**CONSTRUCTION PLANS**  
**PLAN AND PROFILE OF PROPOSED**  
**BELFORD AVENUE BRIDGE AND HAPPY CANYON CREEK**  
**TOWN OF PARKER, COUNTY OF DOUGLAS, STATE OF COLORADO**

As Constructed	BELFORD-HAPPY CANYON CREEK TITLE SHEET			Project No./Code
No Revisions:	Designer:	DCS	Structure	
Revised:	Detailer:	DCS	Numbers	
Void:	Subset:	Title	Sheets:	T-1 of 1
				Sheet Number 1

As Constructed	BELFORD-HAPPY CANYON CREEK BRIDGE		Project No./Code
No Revisions:	SUMMARY OF QUANTITIES		
Revised:	Designer: J. LYNCH	Structure Numbers	
Void:	Detailer: R. DILLON	Numbers	
	Subset: BRIDGE	Sheets: B2 of 34	Sheet Number 31

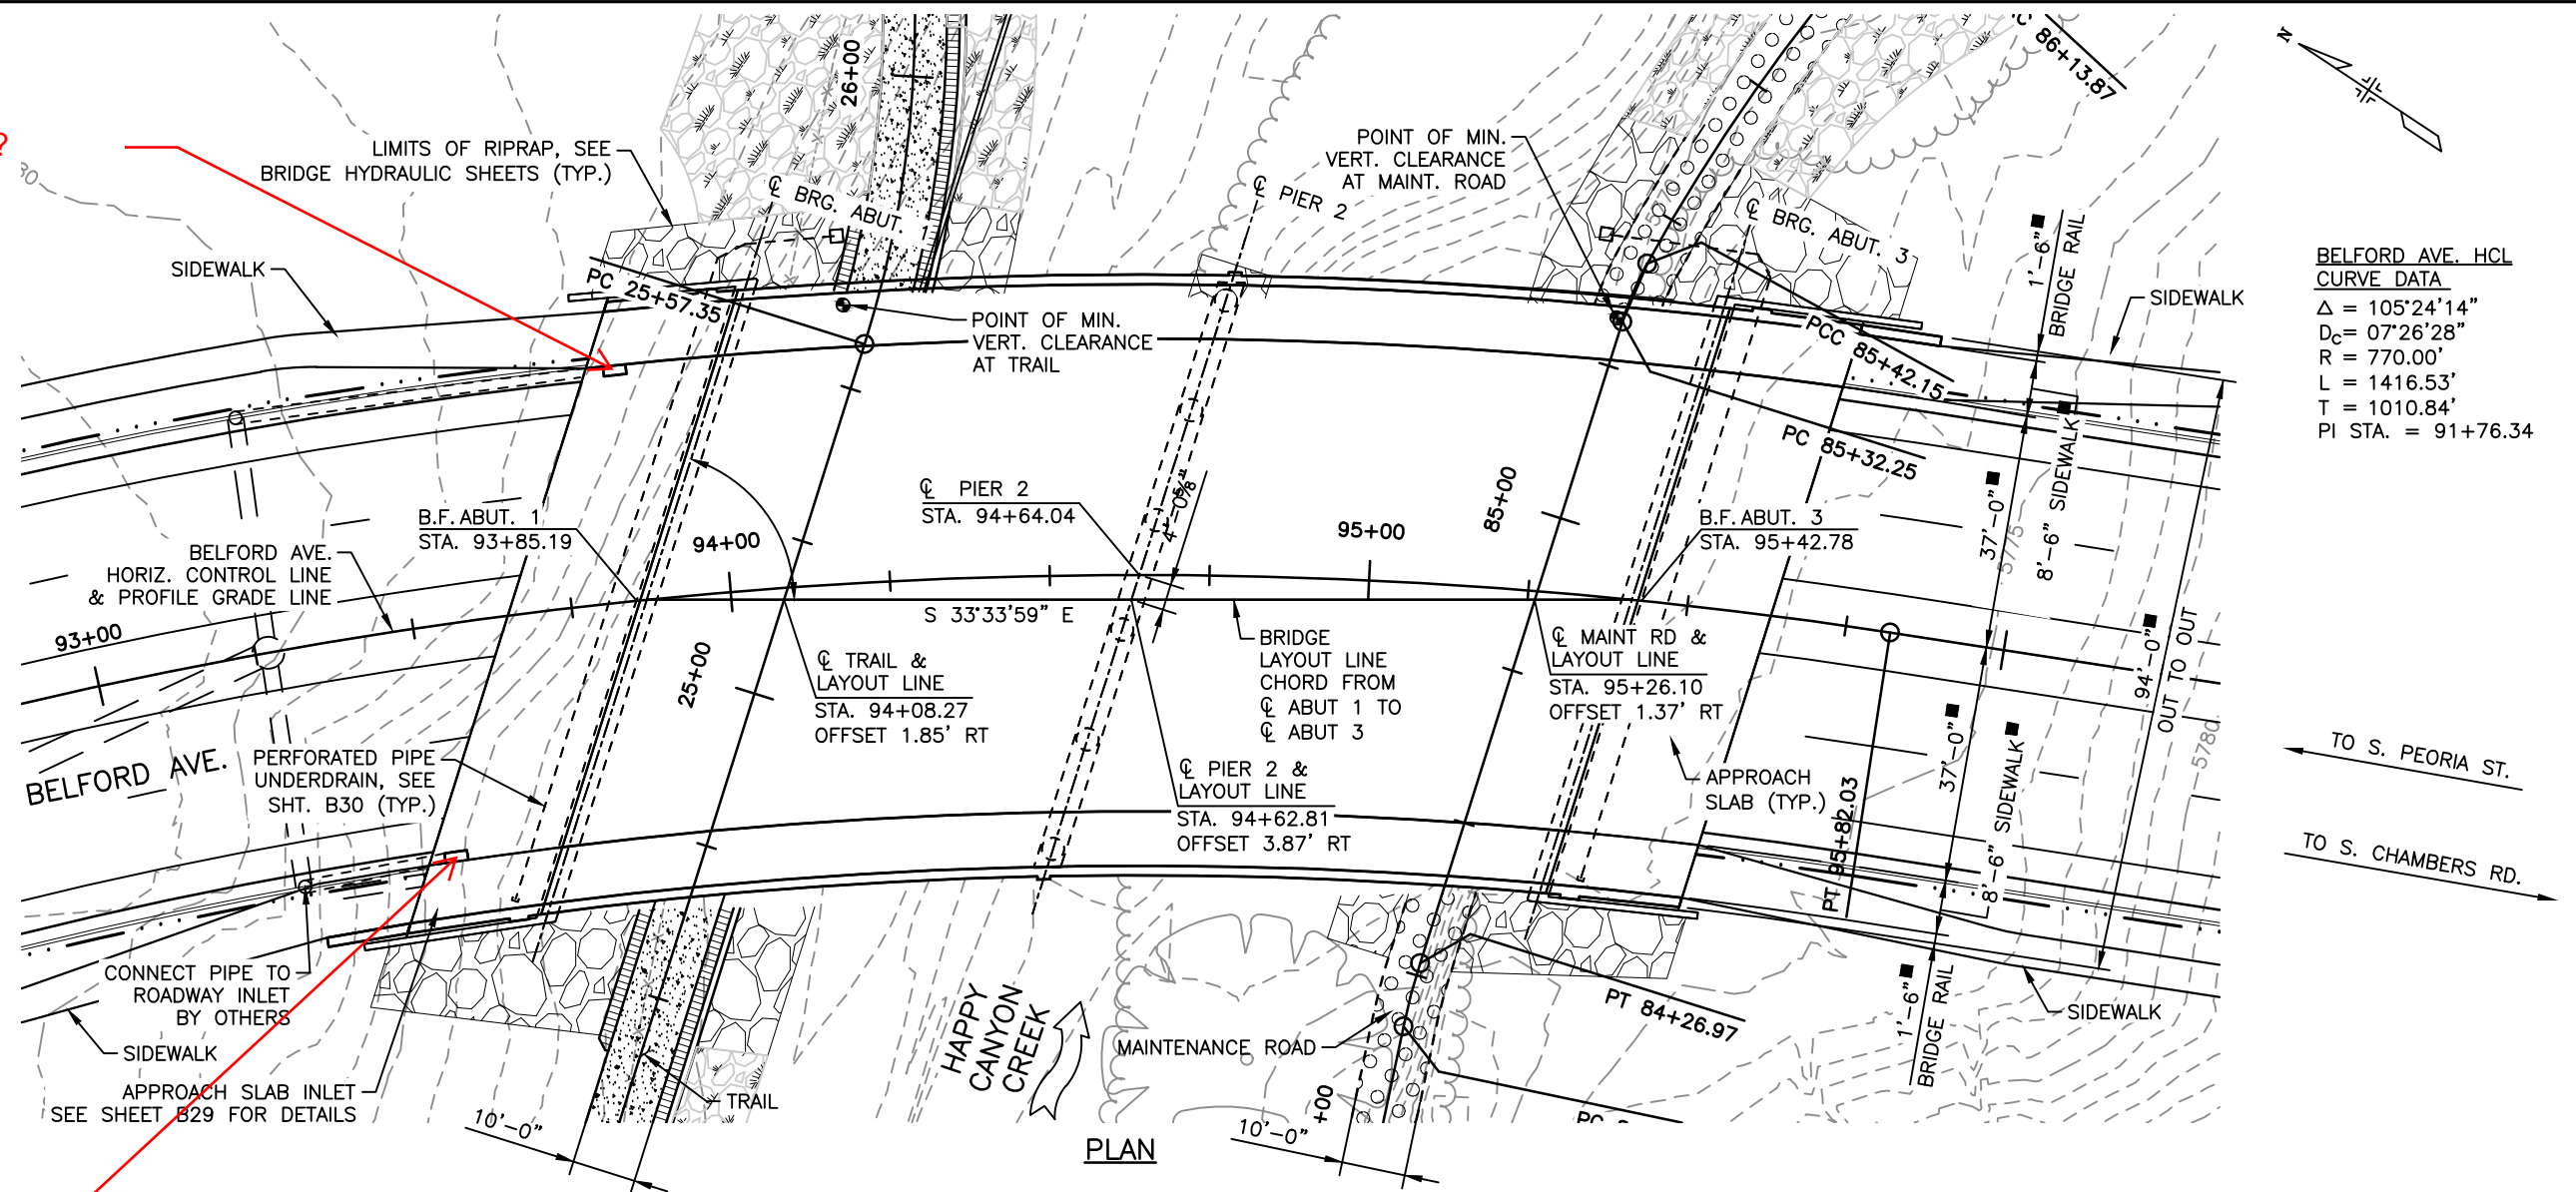
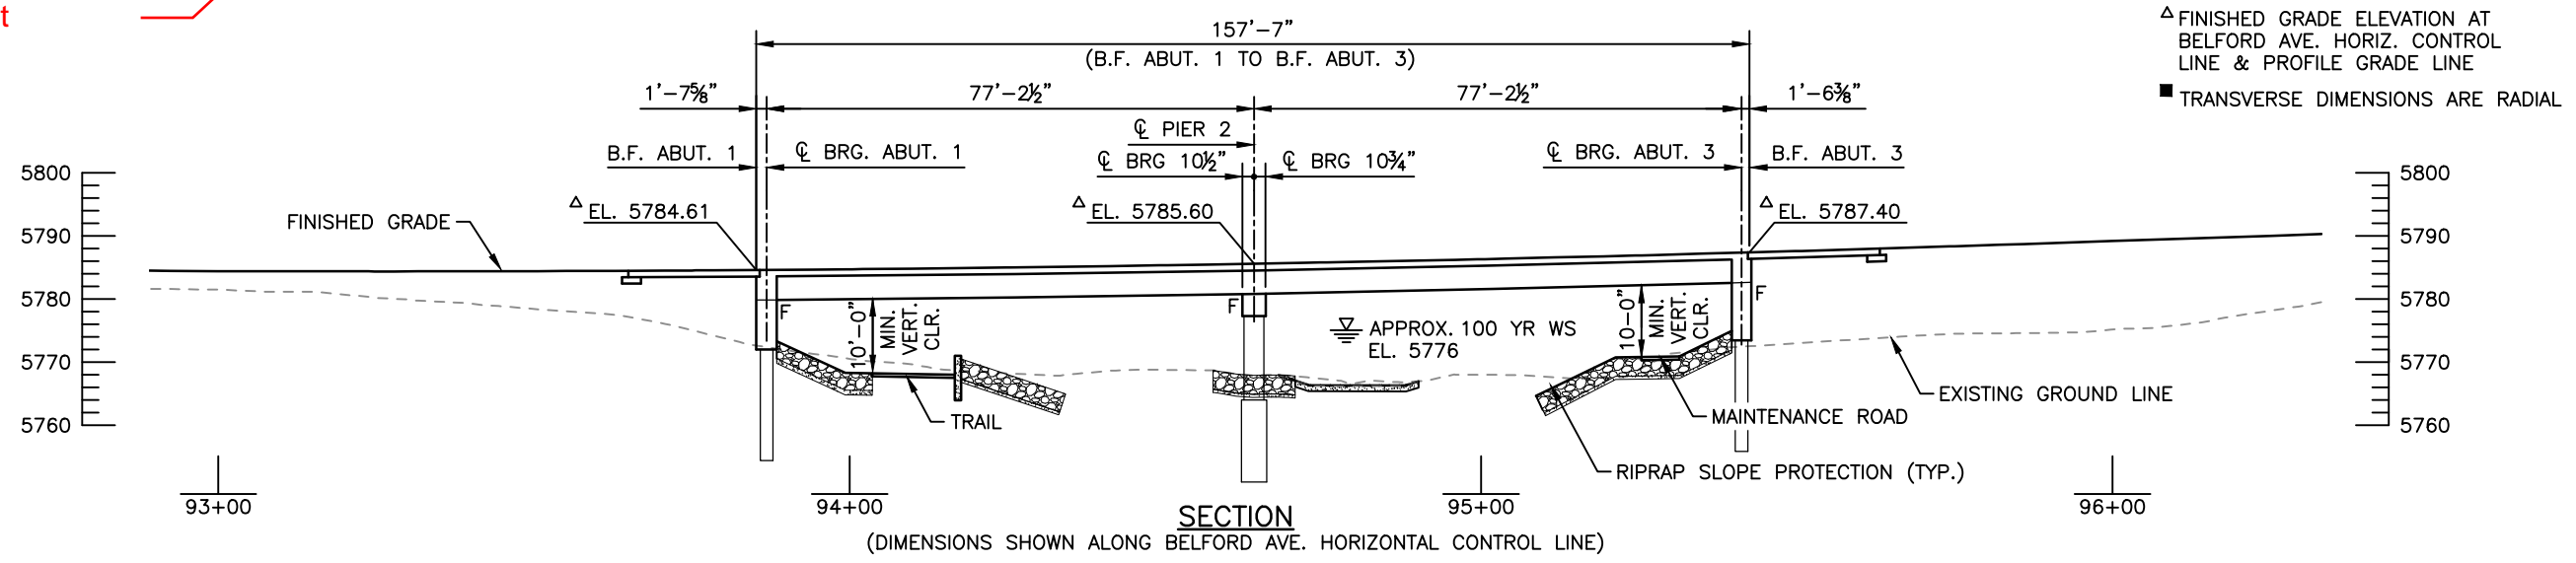
drainage inlet?

drainage inlet

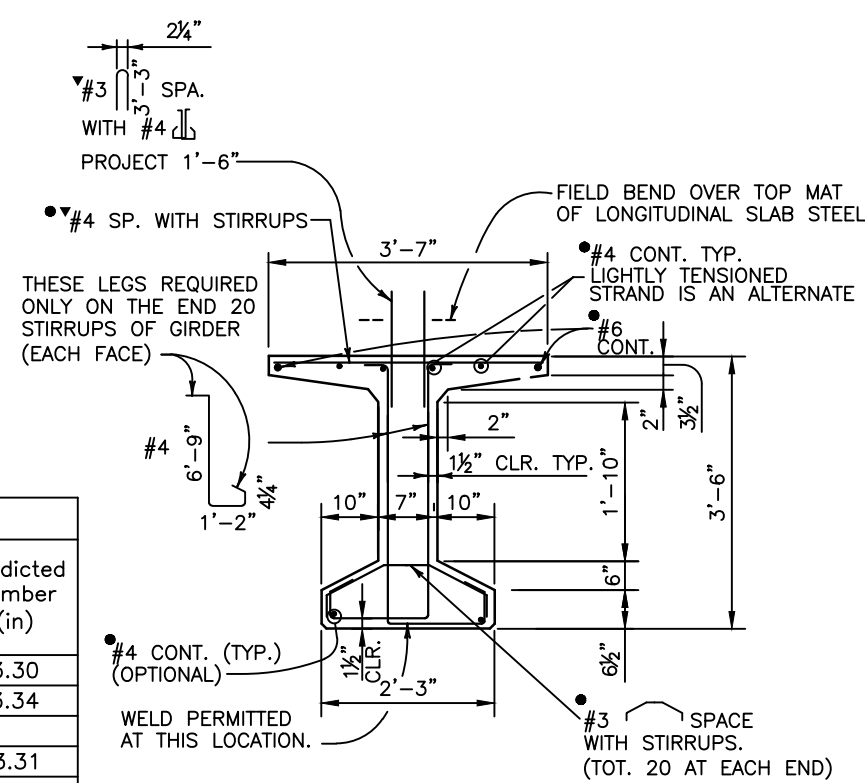
see previous comment

As Constructed	BELFORD-HAPPY CANYON CREEK BRIDGE		Project No./Code
No Revisions:	BRIDGE RAIL PLAN & SECTIONS		
Revised:	Designer: J. LYNCH	Structure Numbers	
Void:	Detailer: R. DILLON	Sheets: B26 of 33	Sheet Number 55

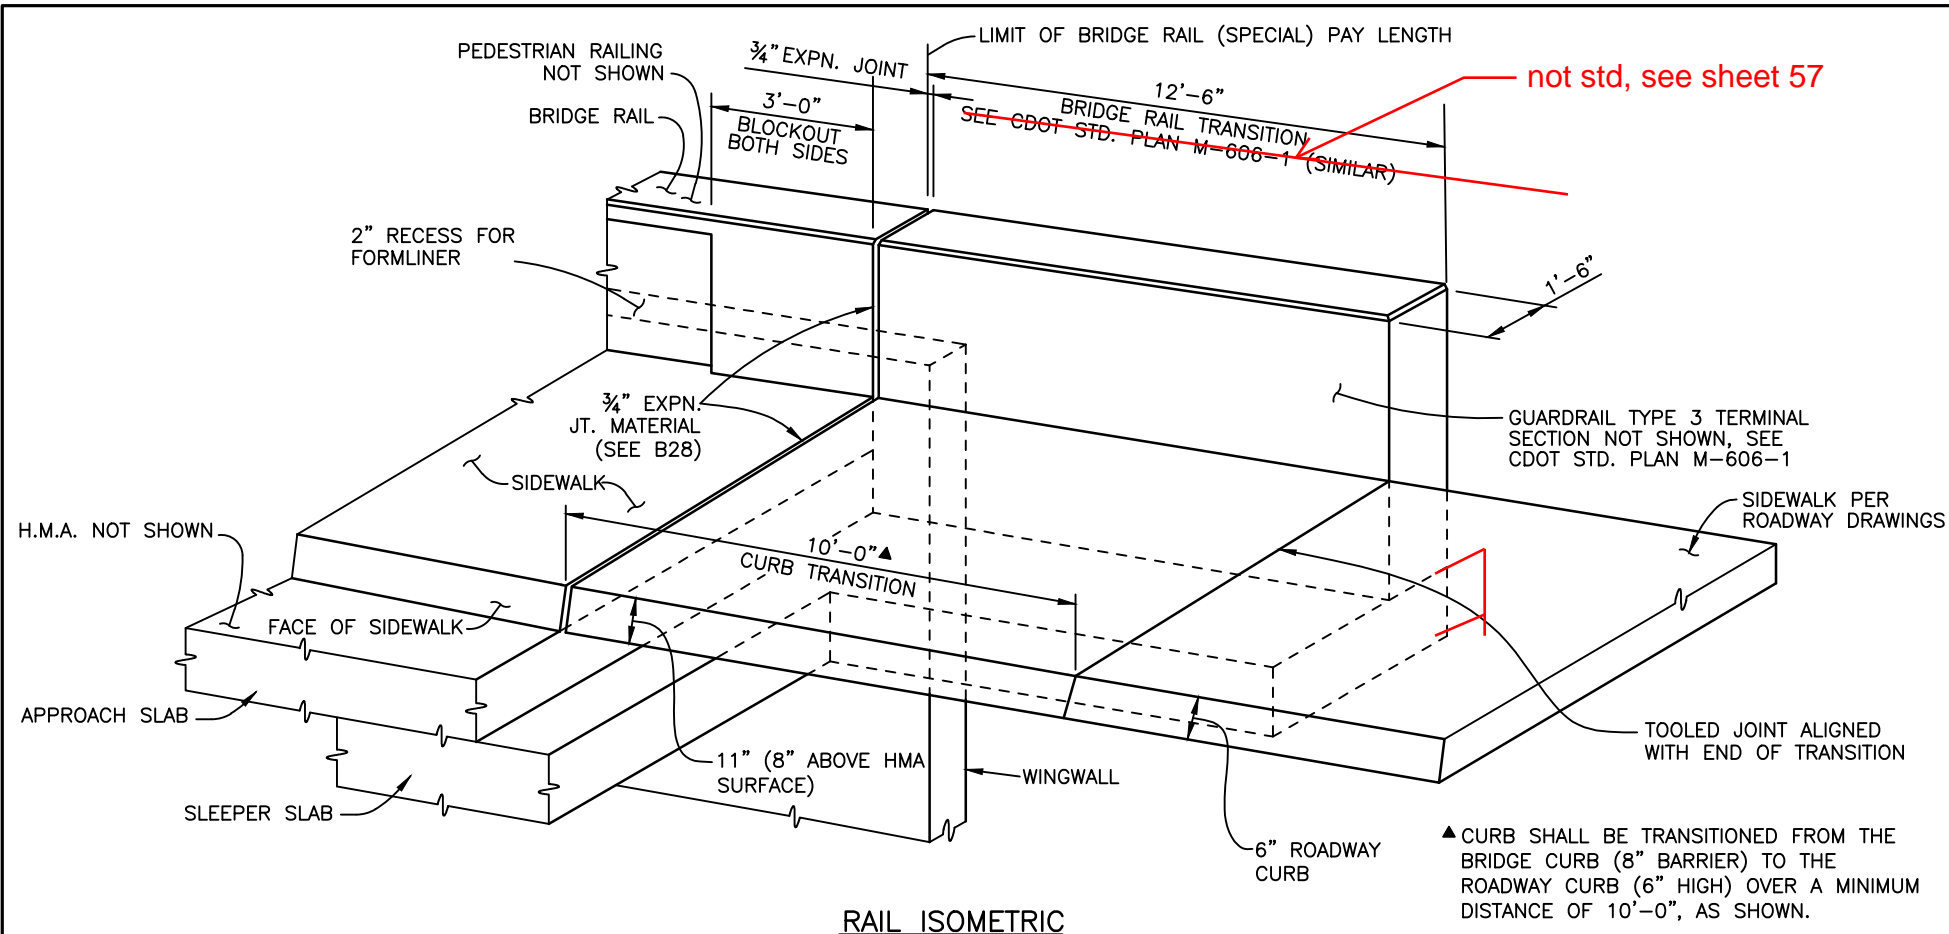
not std, see sheet 57
